Somis Ranch Farmworker Housing Complex

Final Environmental Impact Report

January 2021

| 2 | Responses to Comments on the Draft EIR..... | 2-1 |

Figure 2-3a Project Site Plan

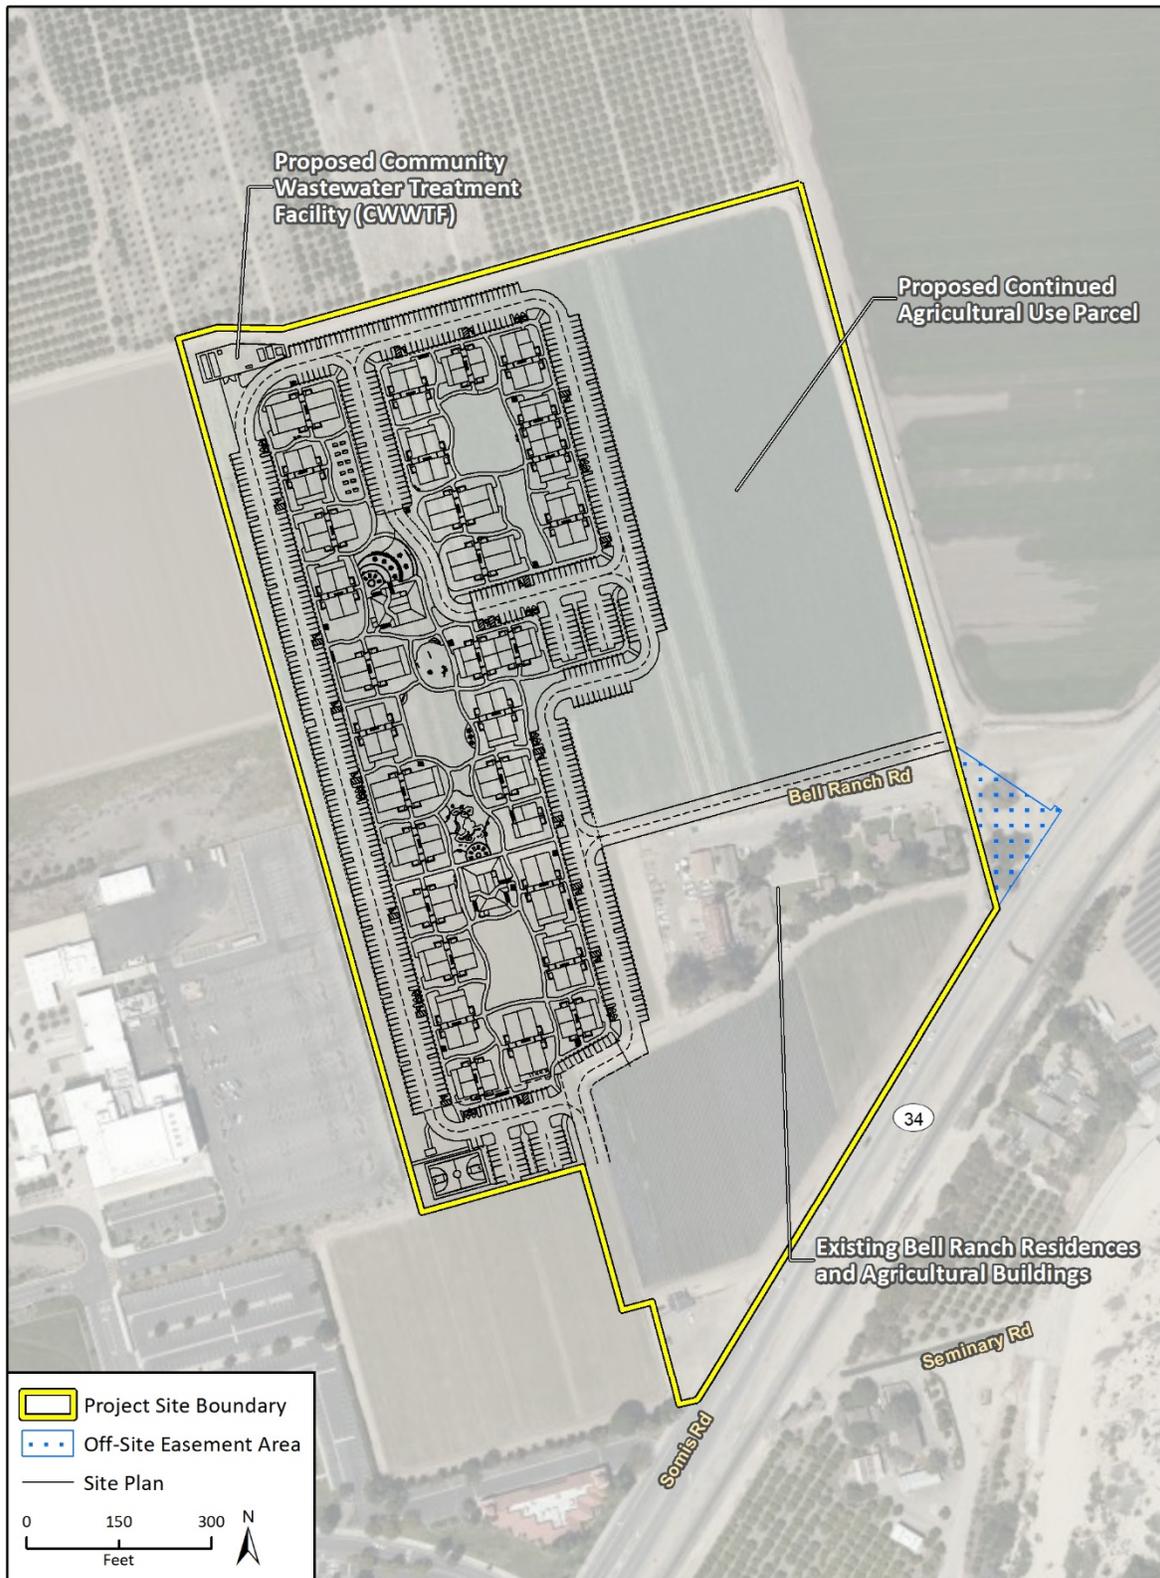
3. **Section 2.5.1.2 and Figure 2-3a** shows one of the access roads (south entrance) will be shared by City's North Pleasant Valley Groundwater Desalter. A portion of this road was designed and will be constructed for access to the Desalter. Additional improvements to the access road, including a bicycle/pedestrian pathway, will be necessary in order to accommodate the number and types of vehicles that will access the proposed project. These additional improvements will be designed and constructed as part of the project, and not by the City of Camarillo. This access road needs to be available to the City's Desalter for its operation.

The Traffic Study has been revised to state a shared access agreement has been established which allows the proposed project to utilize the City's Desalter access road, which would be used as the southern access to the project site.

Figure 2-3b Housing Complex Site Plan

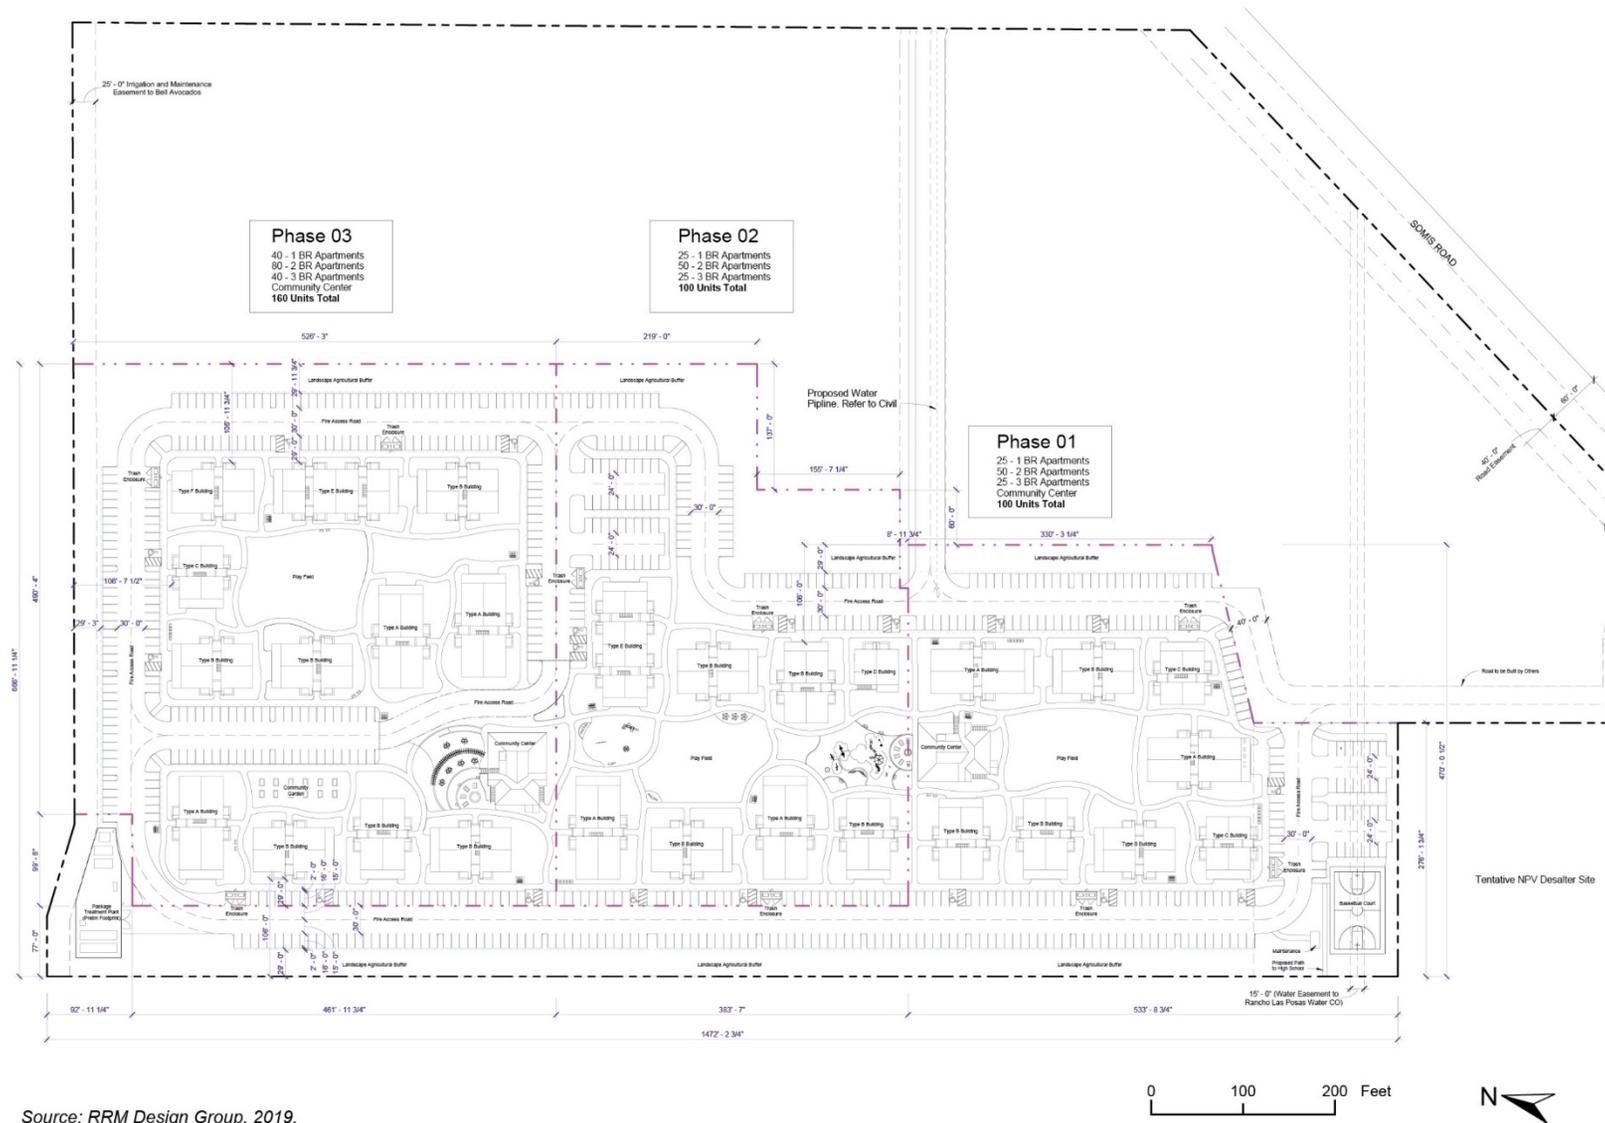
2. **Site Plan:** Show the two driveways that the project will take access from Somis Road on the site plan. 1.3
3. **Noise Impacts:** Construction noise should be analyzed for potential impacts to Rancho Campana High School. Although these impacts may be temporary and therefore not constitute a significant impact, it should be evaluated and mitigation should be considered in order to reduce any temporary impacts. 1.4

4. **Section 2.5.1.2 and Figure 2-3b "Road to be built by others"** – Please clarify who are "the others".

| Pg 2-8 | Figure 2-36: Housing Complex Site Plan is unreadable within the electronic format. | 9.3 |

It was determined the addition of the access driveways to Figure 2-3b, Housing Complex Site Plan, in the Draft EIR would make the site plan illegible. The draft Tentative Parcel Map has been added as Appendix N to this Final EIR and includes the two access driveways.

The commenter requests clarification on a label in Draft EIR Section 2.5.1.2 and Figure 2-3b titled "Road to be built by others."

The text on page 2-11 of the Final EIR has been revised to clarify the improvements to the southern access road:

In response to this comment, Figure 2-3b, *Housing Complex Site Plan*, has been revised in the Final EIR to show a school bus turnout at the project site. The school bus turnout would be located near the southern vehicle access point to the housing complex.

An updated Figure 2-3b, Housing Complex Site Plan, has been added to the Final EIR in 11 x 17 format.

Figure 2-3b, *Housing Complex Site Plan*, has been revised in the Final EIR to show a school bus turnout at the project site. The school bus turnout would be located near the southern vehicle access point to the housing complex.

Figure 2-3b, Housing Complex Site Plan, on page 2-9 of the Draft EIR has been updated as shown at the end of this section on page 3-9.
